**Common SRD Version Two, Revision c List of Changes through 31 May 2000 since  
Version Two, Revision b 25 February 2000**

**CCBD 00019**

**Figure 3.2.4.8.2.3 Command and Data Handling Interface Topology**

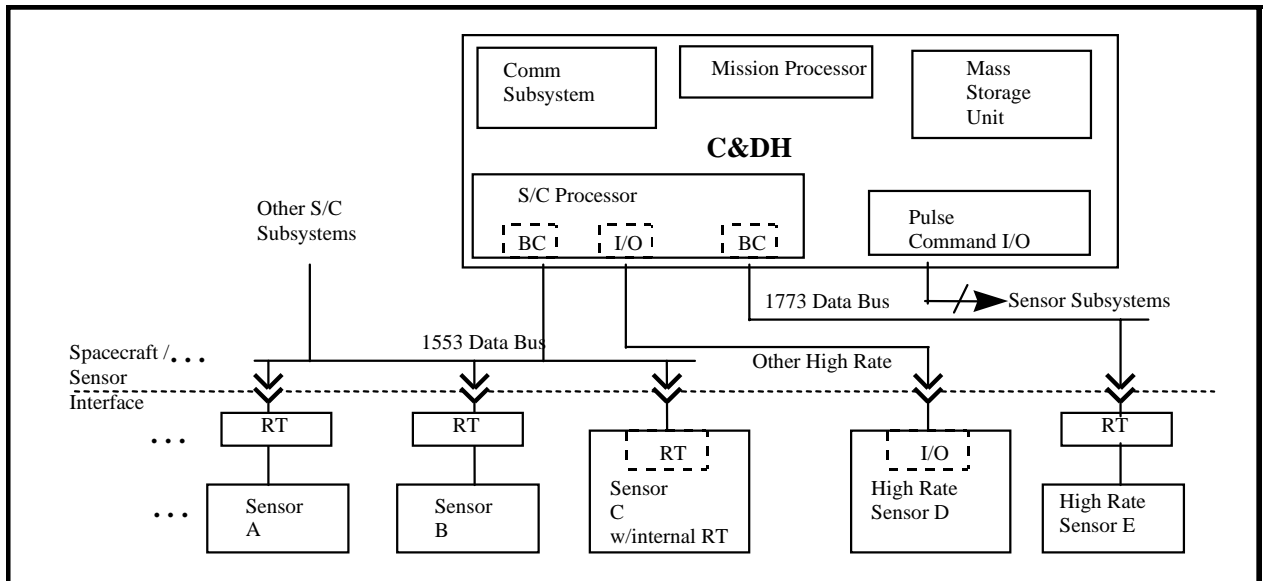
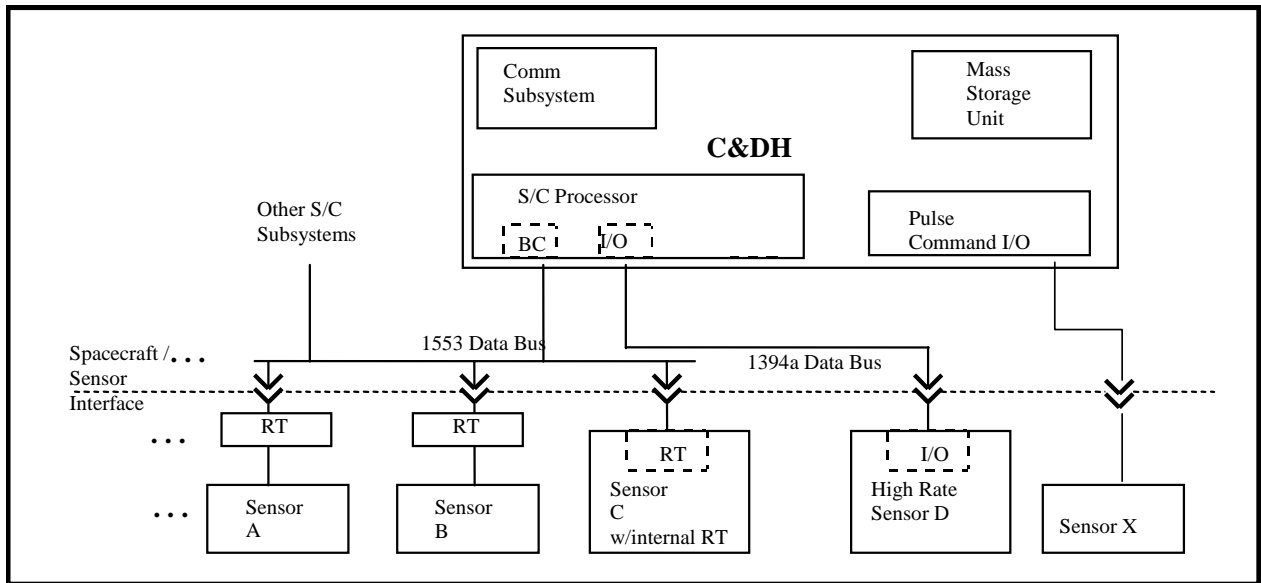
The C&T Data Bus requirements listed below can be satisfied by a data bus (such as MIL-STD-1553B for lowrate mission data, or IEEE-STD-1394a for high rate mission data). The 1394a bus topology is daisy-chain (TBR). The choice of a particular data bus for a sensor will depend on the data rate for that sensor. [Note: the use of any other

connection will require a waiver/deviation.] Multiple data buses may be utilized on the satellite. However, each instrument will utilize either the 1553 low-rate bus, or the 1394a high-rate bus, but not both. Instruments with data rates in excess of 50 kbps will be assigned to the 1394a, high rate data bus. Instruments with data rates up to and including 50 kbps will be assigned to the 1553, low rate bus.

Each C&T data bus shall be standby redundant, and shall fully comply with the requirements of IEEE-STD-1394a (all relevant sections, as further defined by the spacecraft-instrument ICD) or Mil-STD-1553B, Notice 2, all sections.
